SUBDIVISION REPORT - CONCEPT

▶ **FILE #:** 3-SB-19-C **AGENDA ITEM #:** 9
 POSTPONEMENT(S): 3/14/2019 **AGENDA DATE:** 4/11/2019

▶ **SUBDIVISION:** THE GABLES AT WESTMORELAND

**3-SB-19-C
CONCEPT PLAN**

Sheet
 CP-01

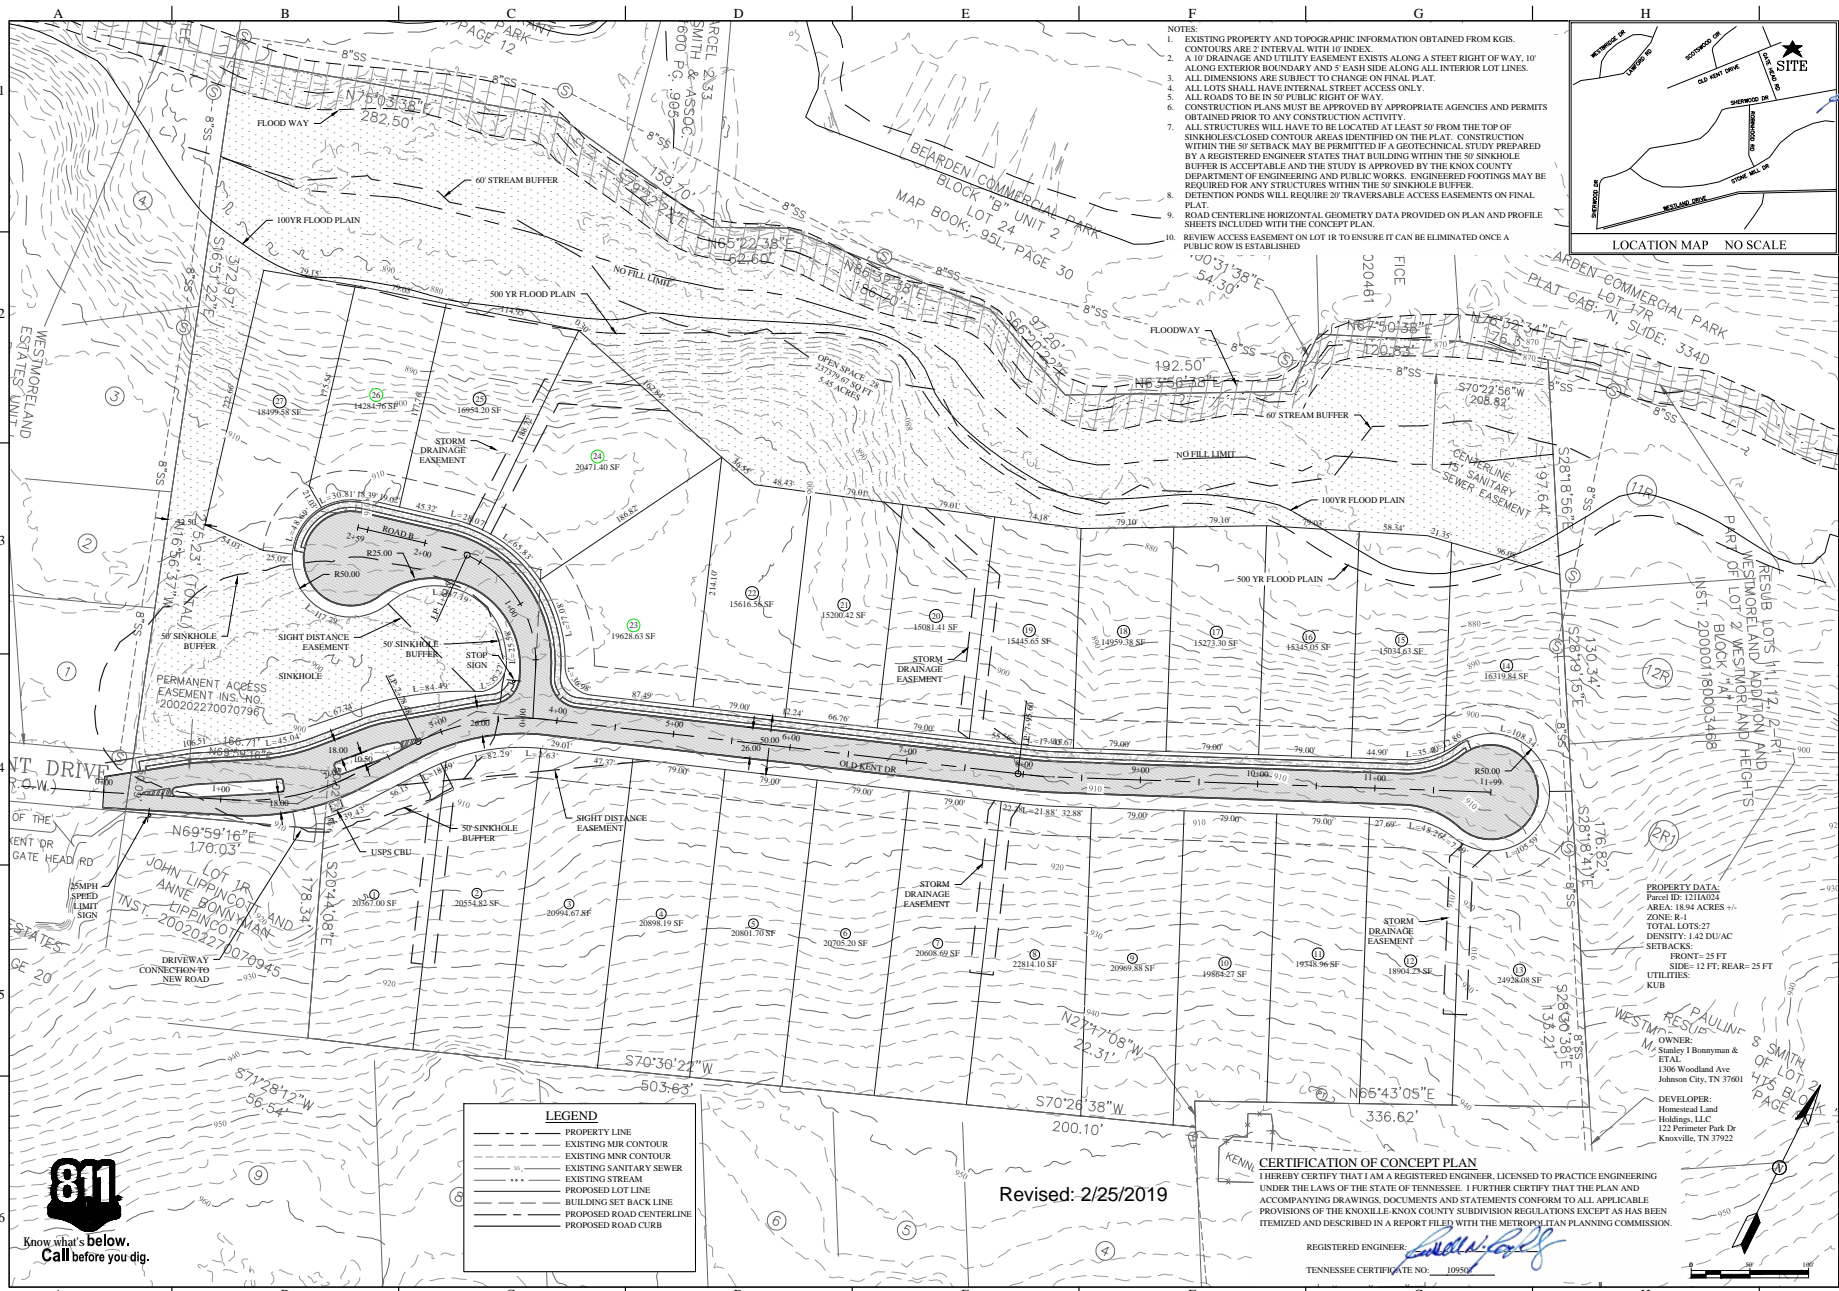
9. Identify the sinkhole and 50' buffer on the final plat.
10. Prior to final plat approval, establish a homeowners association for the purpose of assessing and collecting fees for the maintenance of the commonly held assets including the common area and the stormwater system.

Sheet
CP-02

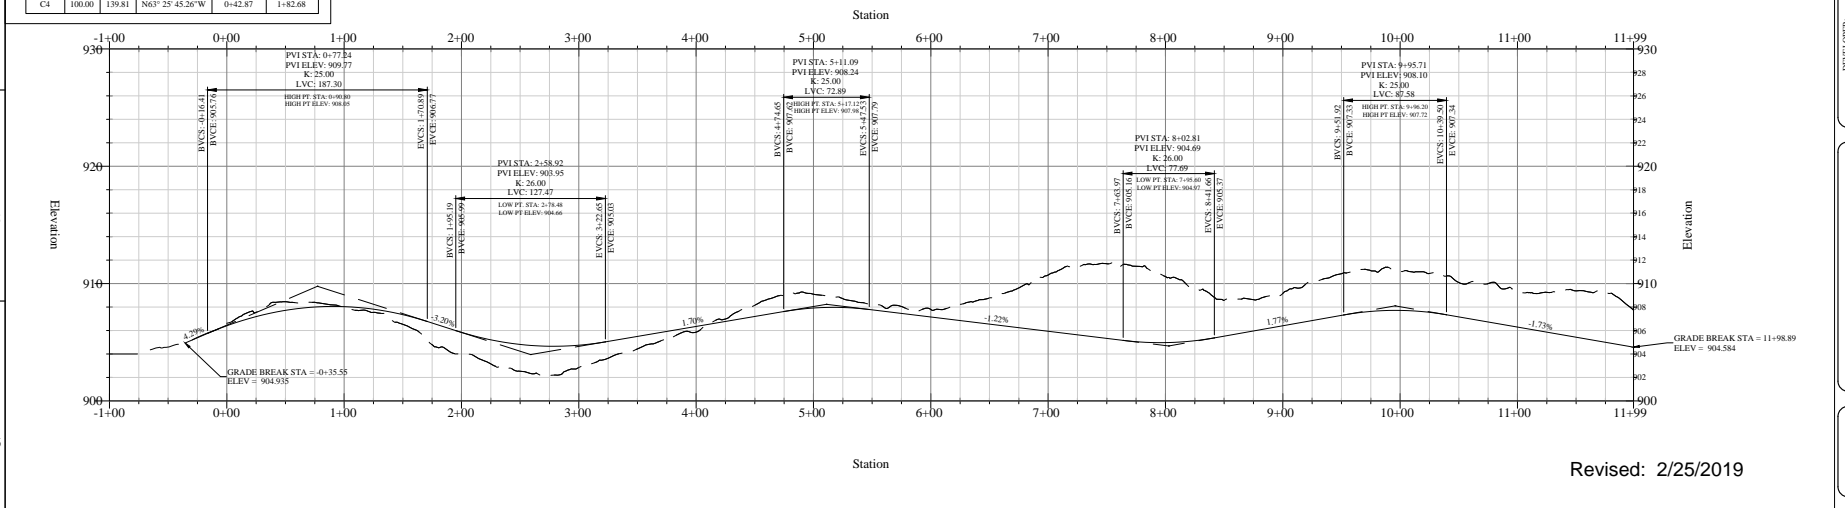
- ▶ **APPROVE the Concept Plan for 27 detached residential units on individual lots, subject to 12 conditions.**
1. Connection to sanitary sewer and meeting any other relevant requirements of the Knox County Health Department.
 2. Provision of street names which are consistent with the Uniform Street Naming and Addressing System within the City of Knoxville (City Ord. 0-280-90).
 3. Installation of sidewalks as identified on the concept plan. Sidewalks shall meet all applicable requirements of the Americans with Disabilities Act (ADA) and the Knoxville Department of Engineering and shall be installed at the time the streets are installed.
 4. Roadway design must meet AASHTO standards. Provide justification to the Knoxville Department of Engineering that supports the 100' horizontal curve radius on Road B. The proposed horizontal curve is subject

to review and approval by the Knoxville Department of Engineering.

5. Provide sight distance verification for intersections and driveways impacted by the curvature of the roadway.
6. The design of the boulevard entrance and proposed mail facility location is subject to review and approval by the Knoxville Department of Engineering during design plan review.
